Addendum / Addenda

Project Description / Description de projet M02M10 Re-Roof Project		
Solicitation No./N° de sollicitation 16-22069	Project No./N° de projet 5230	W.O. No./N° d'ordre de travail A1-006900-03-01
Departmental Representative / représentant ministériel Kirk Williams		Date September 6, 2016
Notice: This addendum shall form part of the tender documents and all conditions shall apply and be read in conjunction with the original plans and specifications.		Nota: Cet addenda fait partie intégrale des dossiers d'appel; toutes les conditions énoncées doivent être lues et appliquées en conjonction avec les plans et les devis originaux.

project: **ROOF REPLACEMENT BUILDING M-02, ROOF AREAS 1, 2, 4 + 5 BUILDING M-10, ROOF AREAS 1, 2 + 5 1200 MONTREAL ROAD, OTTAWA NATIONAL RESEARCH COUNCIL**

drawing: **ROOF AREA 1, PLAN AND DETAILS BUILDING M-02**

Notes:
 1. CONTRACTOR IS RESPONSIBLE TO VERIFY ALL DIMENSIONS AND CONFIRM EXISTING CONDITIONS.
 2. NOTIFY CONSULTANT IMMEDIATELY OF ANY DEVIATIONS FROM ASSUMED EXISTING CONDITIONS AS THEY ARE ENCOUNTERED ON SITE.
 3. DRAWINGS ARE NOT TO BE SCALED.

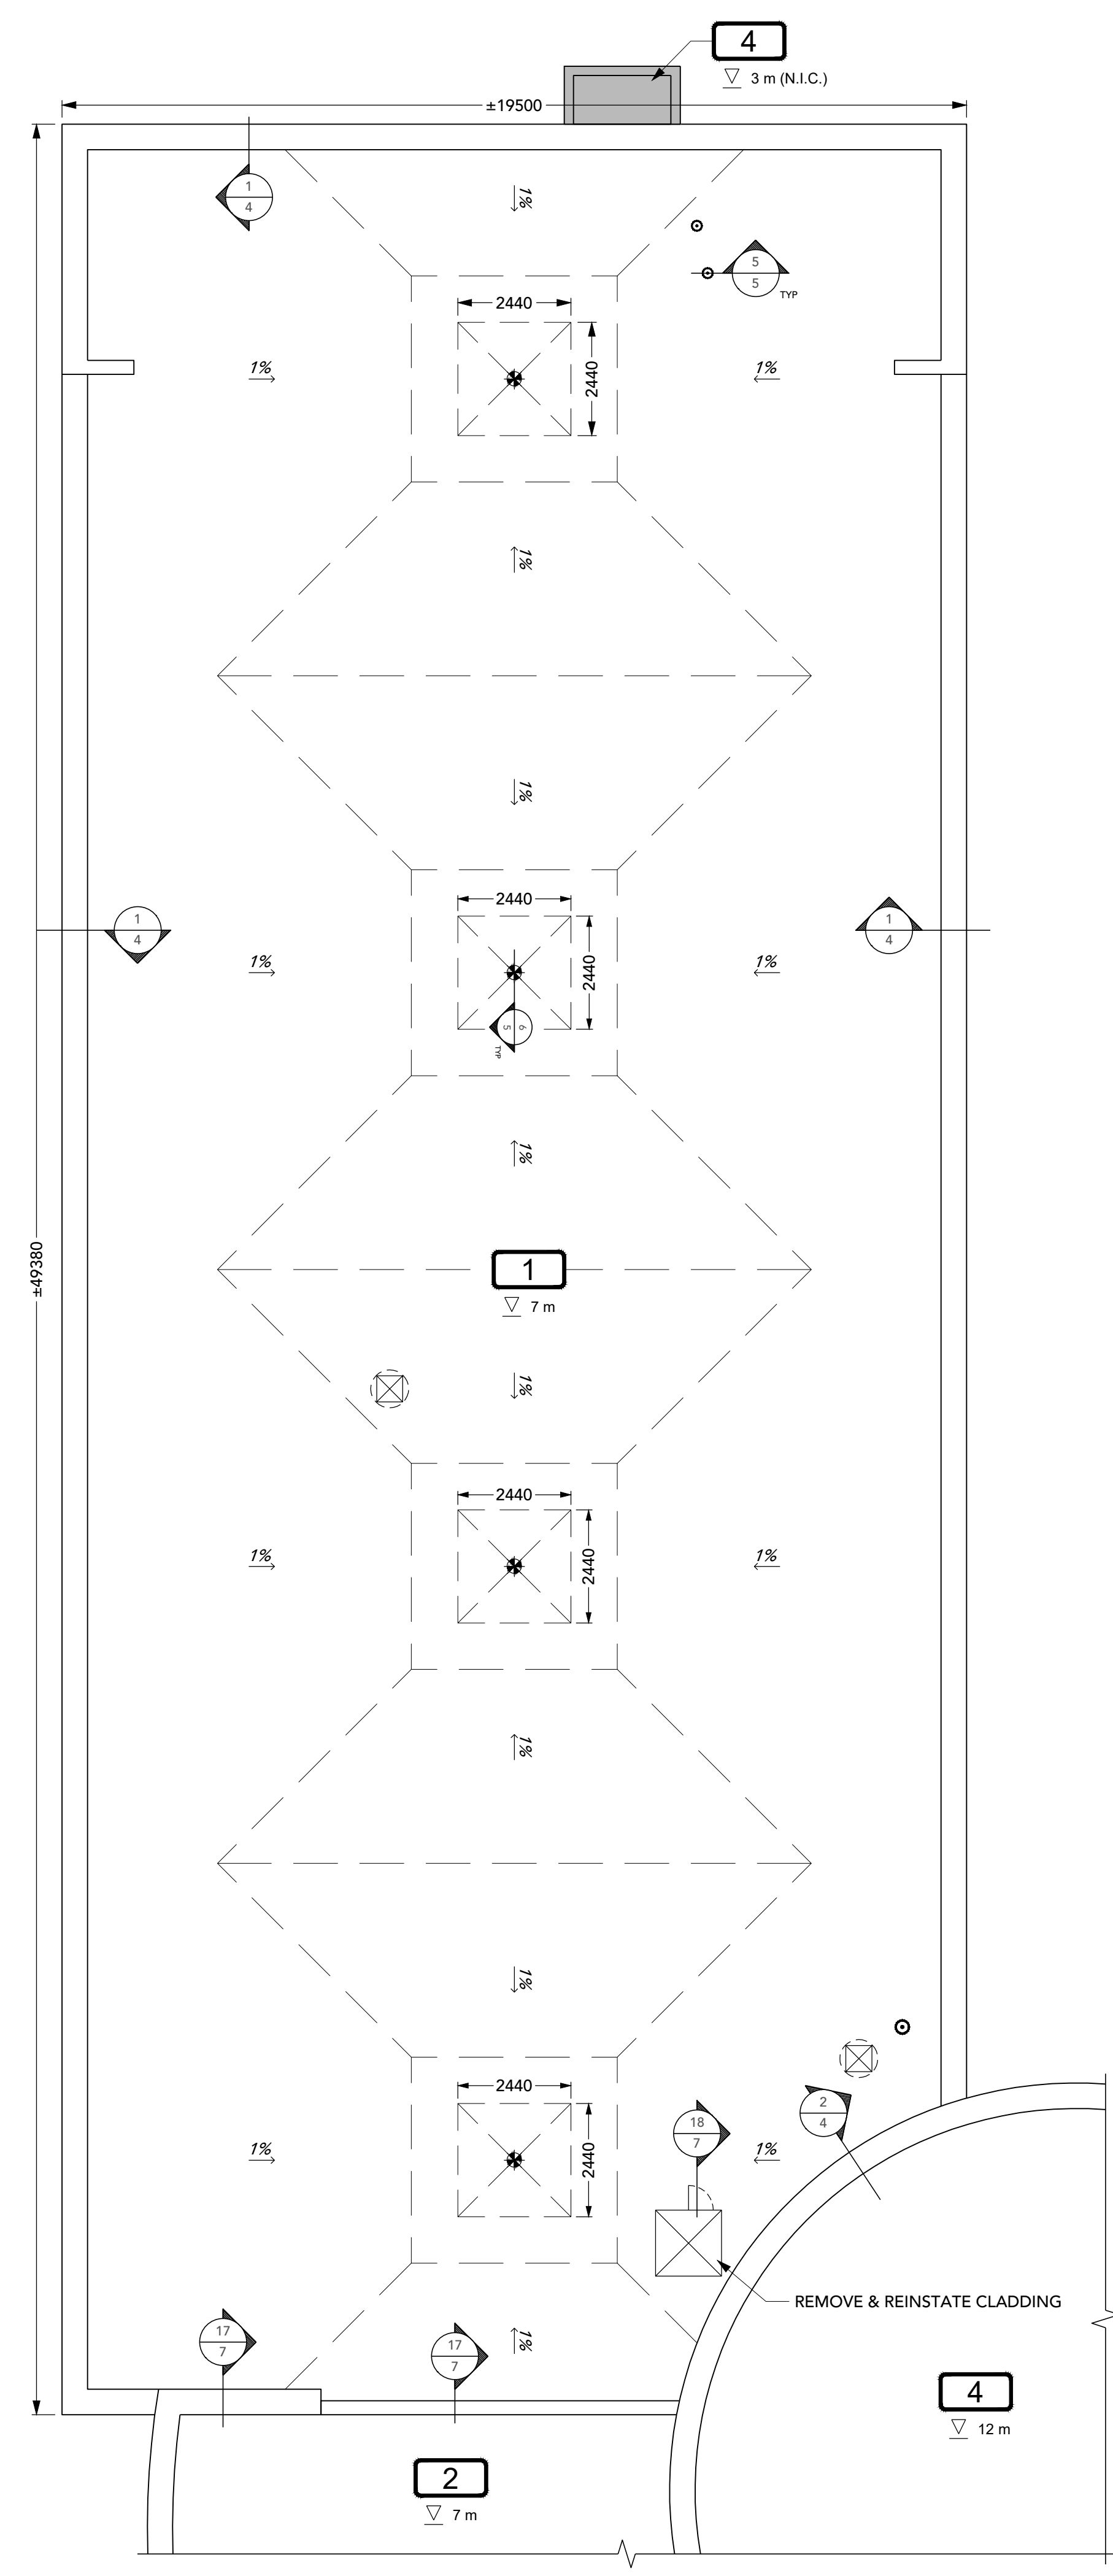
3. Add north wing of Building M2 to contract as indicated on roof plan drawing, attached. Construction detailing and specifications are provided in the original documents.
4. The Mandatory Site Visit Attendance Sheets are attached.
